PLANNING COMMISSION MEETING THURSDAY, JANUARY 12, 2017

DOCUMENTS RECEIVED AFTER PUBLISHED AGENDA

MISSION BLVD & INDUSTRIAL PARKWAY MIXED-USE DEVELOPMENT

REVISED CONDITIONS OF APPROVAL

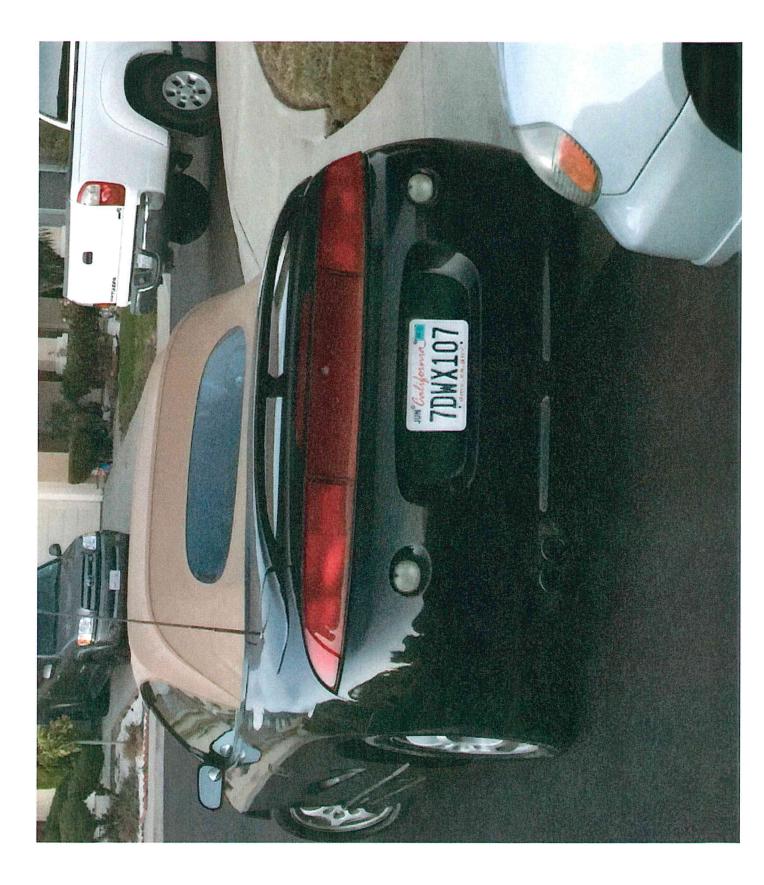
Cars consistently park in red zones on Industrial and Bridgehead; park on both the right and left of the Twin Bridges Industrial-Arrowhead entrance extending so far out and into the crosswalks that they block the view of drivers trying to turn right on to Industrial.

Attached are just 2 examples of serial illegal parking - both cars freely and consistently block driveways or handicapped curb ramps. This practice will continue unless Twin Bridges is considered part of the project impact study. This silver SUV has been blocking the handicap ramp for more than 4 days with no consequence.
